**ZONING AMENDMENT  
& SUBDIVISION STAFF REPORT****Date: August 18, 2011****APPLICANT NAME**

2056 Corporation Subdivision

2056 Dr. Martin Luther King Jr. Avenue  
(East side of Dr. Martin Luther King Jr. Avenue, 100'±  
South of Crawford Lane)

B-2, Neighborhood Business District

# SITE PLAN

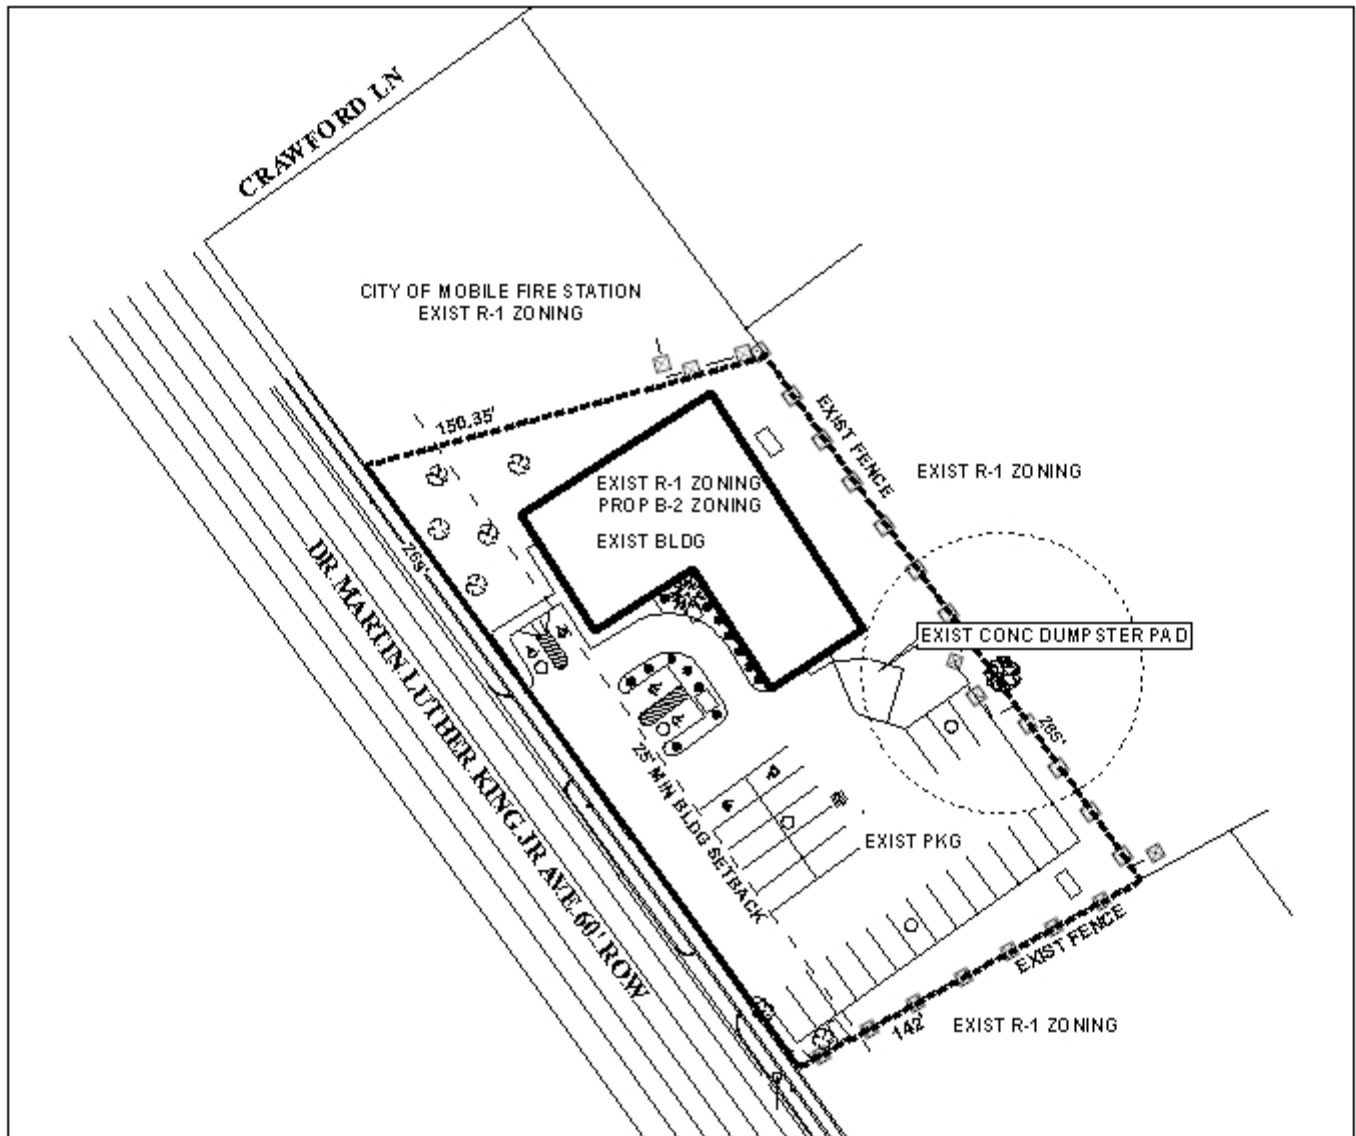
The 25-foot minimum building setback is depicted on the plat and the site plan. The size of the proposed lot, in square feet, is not indicated on the plat.

While Zoning review is not site plan specific, staff would like to point out that the site plan does not depict an existing drive-through canopy. Also, the site plan does not depict one-way circulation under this canopy, which should be required, due to the narrowness of the drive-through. One way arrows and signage should be required.

The site plan depicts an existing dumpster pad. Any dumpsters should be enclosed with a 6-foot high enclosure, and per Engineering comments, dumpster pads must be connected to the sanitary sewer system.

While the Zoning Ordinance does not require compliance with the Americans with Disabilities Act, it should be pointed out that the site plan does not appear to comply with the parking requirements of the ADA. Specifically, there should be at minimum one “van accessible” space with an adjacent 96-inch wide access aisle, and all other designated handicap spaces must be adjacent to a 60-inch wide access aisle. The ADA additionally requires the placing of signs at each space indicating that the parking is reserved for handicapped individuals, and the site should have an accessible route to the adjacent public sidewalk.

- 1) Marking of the drive-through area as one-way, to include pavement and signage markings;
- 2) Compliance with Urban Forestry comments (*Full compliance of the landscaping and tree requirements to be coordinated with Urban Forestry. Property to be developed in compliance with state and local laws that pertain to tree preservation and protection on both city and private properties (State Act 61-929 and City Code Chapters 57 and 64). ;*

- 5) Provision of a 6-foot high enclosure around the dumpster pad area;

- 6) Modification of any existing or proposed site or parking lot lighting to comply with Sections 64-4.A.2. and 64-6.A.3.c. of the Zoning Ordinance;
- 7) Verification by the design professional that the site and parking complies with the requirements of the Americans with Disabilities Act;
- 8) Obtaining of building permits as needed to make any required site improvements; and
- 9) Full compliance with all other municipal codes and ordinances.

- 4) Revision of the final plat to label the size of the lot in square feet; and
- 5) Placement of a note on the final plat stating that the site must be developed in compliance with all local, state and Federal regulations regarding endangered, threatened or otherwise protected species.
